**METROPOLITAN DEVELOPMENT COMMISSION**

**Case Number:** 2025-ZON-077  
**Property Address:** 6501 Mann Road (Approximate Address)  
**Location:** Decatur Township, Council District #21  
**Petitioner:** Kittle Property Group, by Joseph D. Calderon  
**Current Zoning:** SU-1 (FF)(FW) and D-A (FF)(FW)  
**Request:** Rezoning of 26.83 acres from the D-A (FF) (FW) district to the D-7 (FF) (FW) district to provide for a multi-family residential development.  
**Current Land Use:** Single Family Residential  
**Staff Recommendations:** Denial  
**Staff Reviewer:** Desire Irakoze, Principal Planner II

**ADDENDUM FOR NOVEMBER 19, 2025 METROPOLITAN DEVELOPMENT COMMISSION**

Amend Site Plan Dated 09/16/2025

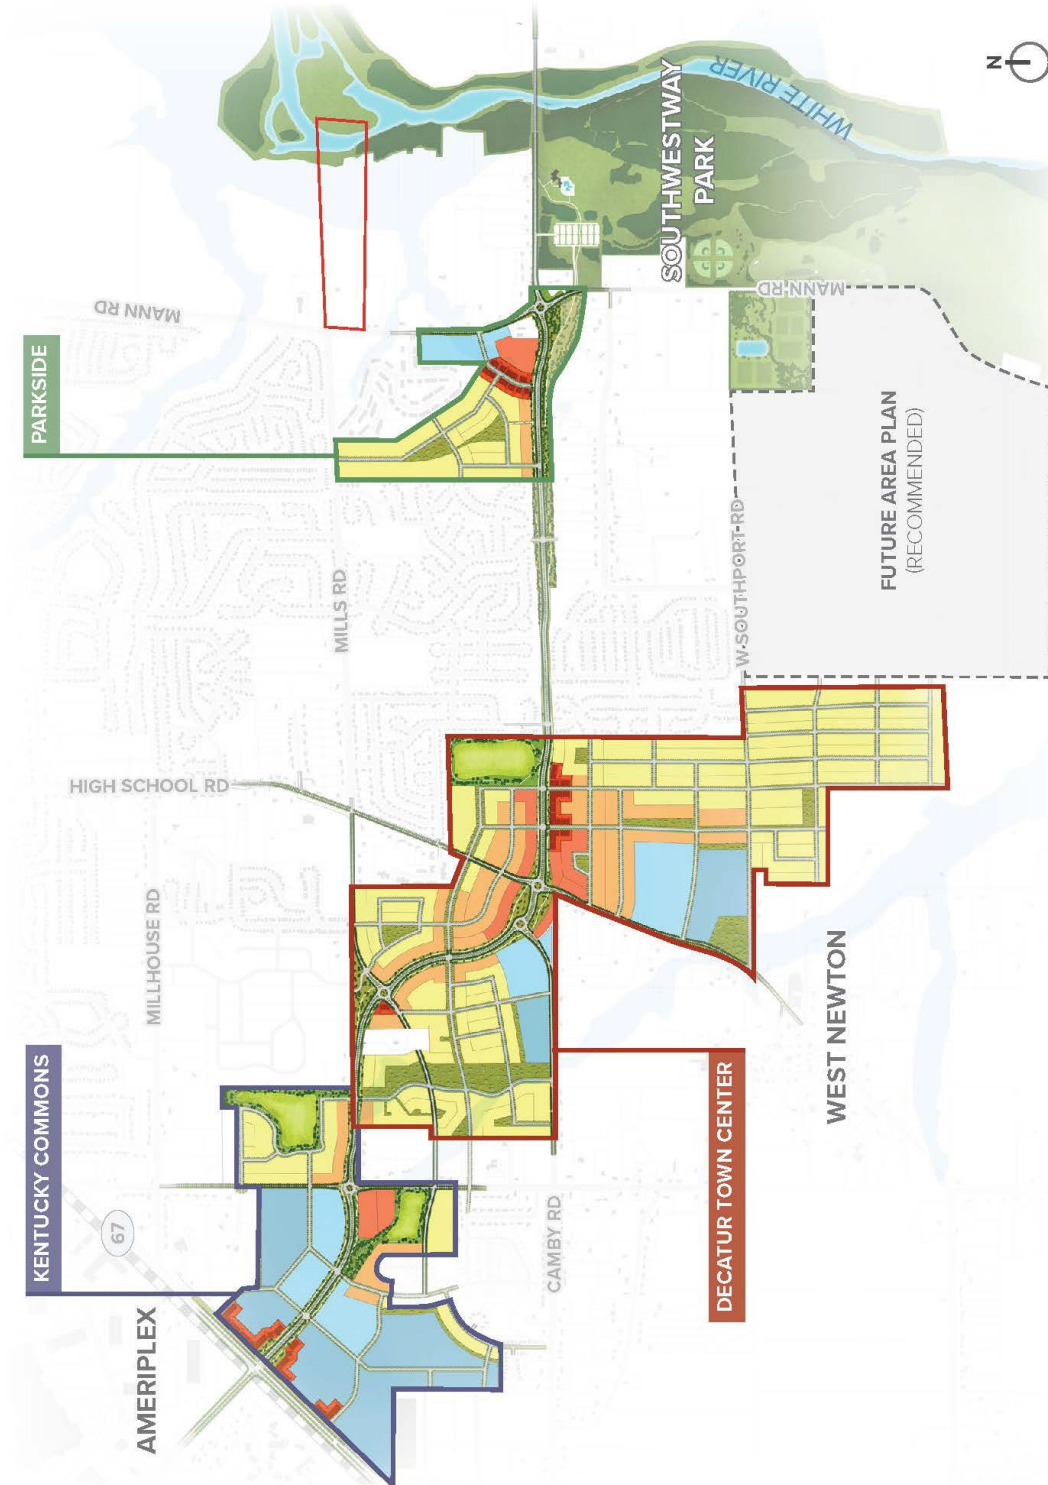
A day prior to the hearing, the petitioner submitted an updated site plan. Due to time constraints, staff had not completed its review of the revised plans before the hearing date.

The updated site plan includes a reduction in the number of parking spaces and an increase in public amenities, as summarized below

The updated site plan also introduces four new amenities, including:

1. An entertainment pavilion with grills
2. Multiple open activity spaces
3. Multiple pocket parks with seating
4. A walking trail easement access

While these revisions represent an improvement over the prior submission, staff continues to recommend **denial** of this request for the reasons outlined in the original staff report.
